Registry No. H-11072

General Locality Approaches to Seward

Descriptive Report to Accompany Hydrographic Survey H11072

Project OPR-P359-RA-01¹
Approaches to Seward, Alaska
Scale 1:10,000
August - September 2001
NOAA Ship RAINIER
Chief of Party: Captain James C. Gardner, NOAA

Figure 3. H11072 Junction Surveys

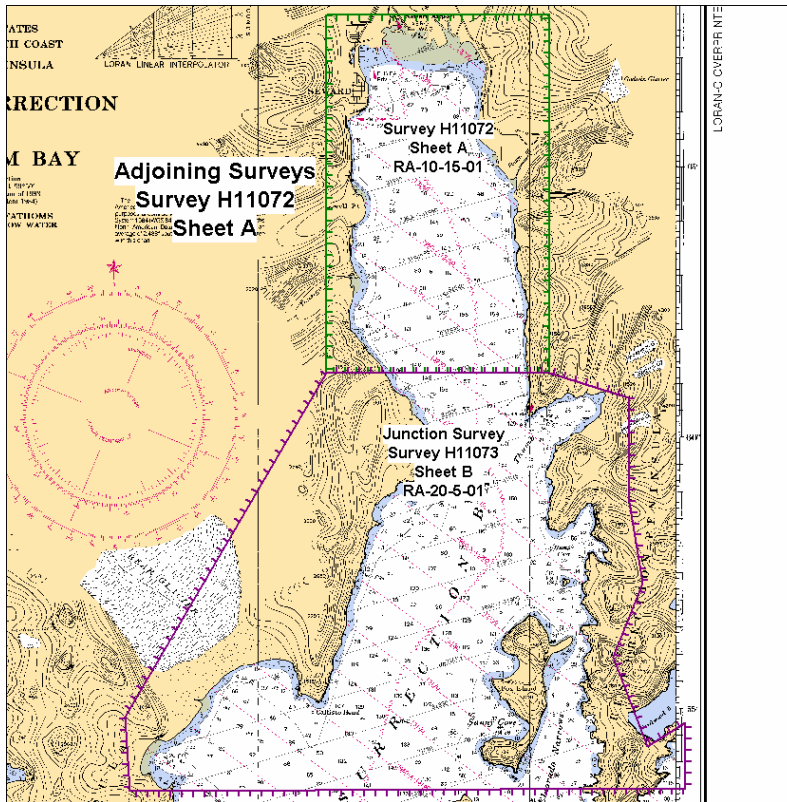
At the time of this report, processing of survey H11073 was not complete. Comparisons of the junction with this survey will be discussed in the Descriptive Report for H11073.⁸

- ⁷ A junction was made during office processing. There was good agreement and a "Joins" note has been added to the smooth sheet. The junction note has been placed on a unique level and turned off for plotting.

Figure 4. Sound velocity error encountered at head of Resurrection Bay

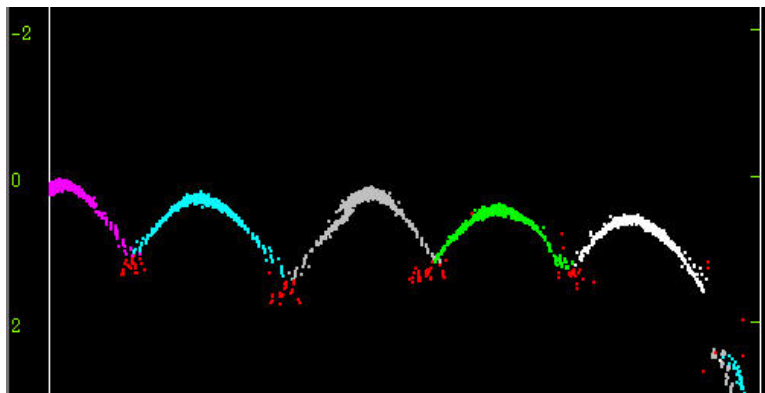
Small errors in the data due to the measurement and application of sound velocity were apparent in the data during subset processing. This was exhibited as "smiles" and "frowns" across multibeam swaths. This was most notable in shallow areas with high fresh water input, including the head of Resurrection Bay and the area immediately north of Lowell point.

Several boat days worth of data were rejected and reacquired, due to large sound velocity errors. The frequency of cast acquisition was also increased. Additional attempts to correct these errors included, applying sound velocity corrector profiles based on the geographic position of the cast, rather than the time the cast was collected. Such application was performed on a line-by-line basis only on individual lines that exhibited profound sound velocity problems.

Despite the best efforts of the Hydrographer to conduct sufficient sound velocity casts distributed both spatially and temporally, and to correct for sound velocity errors in post processing through methods previously mentioned, sound velocity errors were still noticeable in lines run at the head of Resurrection Bay. Data collected by vessel 2126 on day number 261 (lines 416_2309 - 420_2208) were determined to not meet depth accuracy standards set forth in the HSSDM. However, the Hydrographer recommends retaining this sounding data, because no contemporary survey data is available in this area. This recommendation is based on the fact that the near nadir beams are least affected by sound velocity. The near nadir beams due to their relative shoal nature, when compared to the outer beams are the soundings which are brought forward during the shoal bias binning.¹⁰

- ¹⁰ Concur with clarification. The area in question is centered at latitude 60°06'50"N, longitude 149°24'36"W and covers an area approximately 1000 meters by 160 meters. The questionable data was inspected in Caris to locate the associated track lines and compared to prior surveys H-8822 and H-8855. Comparison between the prior surveys and the depth data in question reflected agreement to within 0.5 to 1.0 fathom. Additionally, inspection of the surrounding survey data area revealed no significant differences. The evaluator recommends charting this data as plotted on the smooth sheet.

Figure 5. Entrance to Seward Dry dock facility

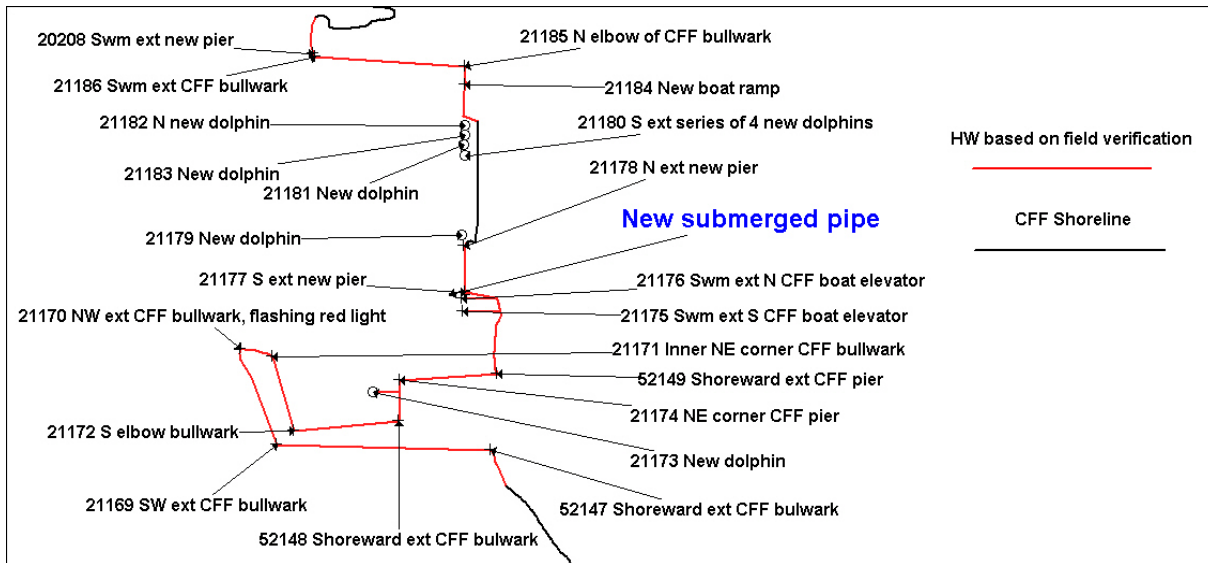
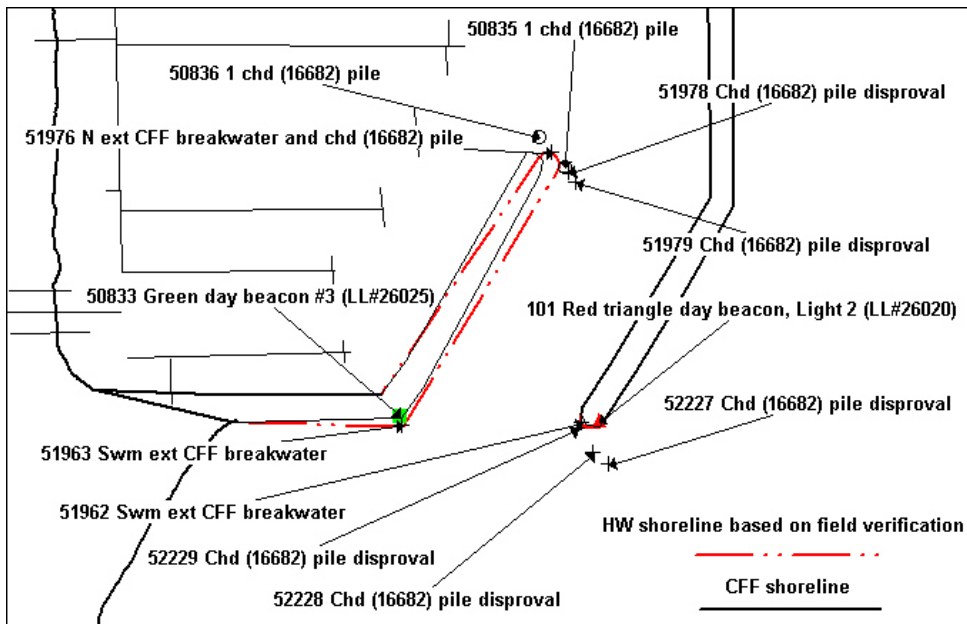
During shoreline verification the Hydrographer observed discrepancies between the CFF shoreline data and the actual shoreline. These discrepancies were in some places more than 18 meters between the CFF Mean-High-Water Line and the actual shoreline.

After discussing these discrepancies with NGS, Remote Sensing Division (RSD), RAINIER was informed that horizontal control in Resurrection Bay at the time of shoreline compilation was considered adequate within H11072 survey limits. In cases where the CFF data varies from data collected in the field, the Hydrographer recommends charting the shoreline as depicted on the Detached Position Plot. ³⁰

³⁰ Concur with clarification. Chart the Mean High Water Line revisions as shown on the smooth sheet.

Figure 8. New Alaska Railroad Freight Dock

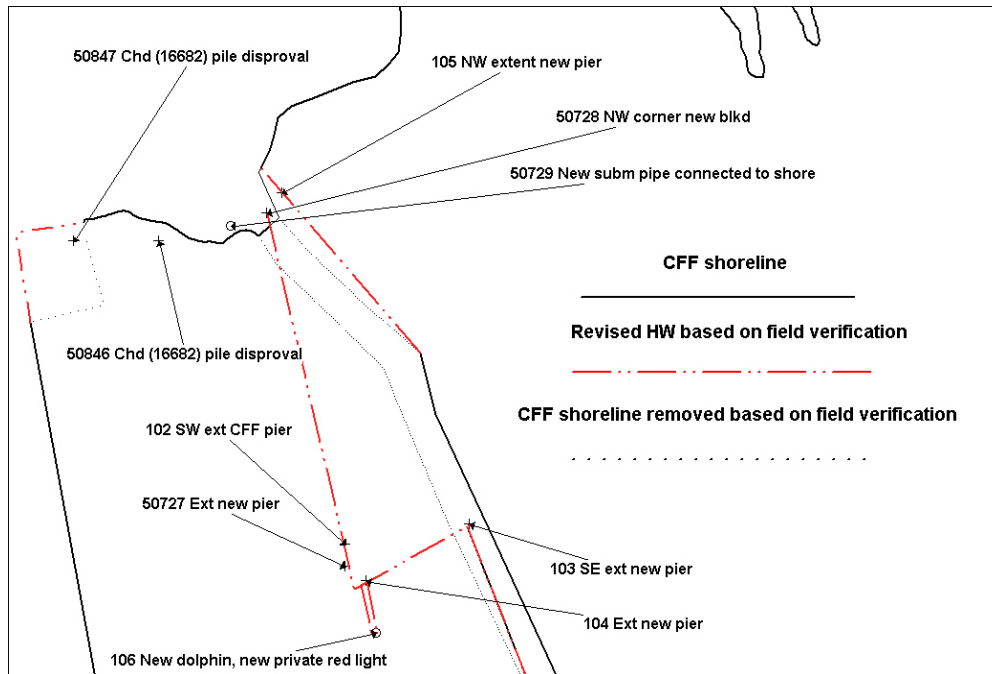
The new Alaska Railroad Freight Dock, located at $60^{\circ}07'07.87''N$, $149^{\circ}25'29.05''W$ was not shown on the CFF vector shoreline data provided by NGS. During the survey H11072, RAINIER personnel positioned the pier using a combination of detached positions obtained from launches (Detached Position 50727-50728) and static GPS surveys (Detached Position 102-106). The Hydrographer recommends revising the shoreline as depicted on the Detached Position and Bottom Sample Plot.³¹ The Hydrographer recommends utilizing any additional existing shoreline data or submitted as built plans available for this area in determining final shoreline.³² The point of contact in Seward is Louis Bencardino at (907)224-5550.

A portion of the Alaska Railroad Freight Dock at $60^{\circ}07'11.28''N$, $149^{\circ}25'38.95''W$ was not observed during survey H11072. During prior visits to Seward, Rainier personnel observed a floating dock at this locale used to offload fishing boats. The charted (16682) dolphin at this location is AWOIS 52791 and is discussed further in the AWOIS section of this report.³³ The Hydrographer recommends revising the shoreline as depicted on the Detached Position and Bottom Sample Plot.³⁴

³⁴ Do not concur. Chart this area using smooth sheet information.
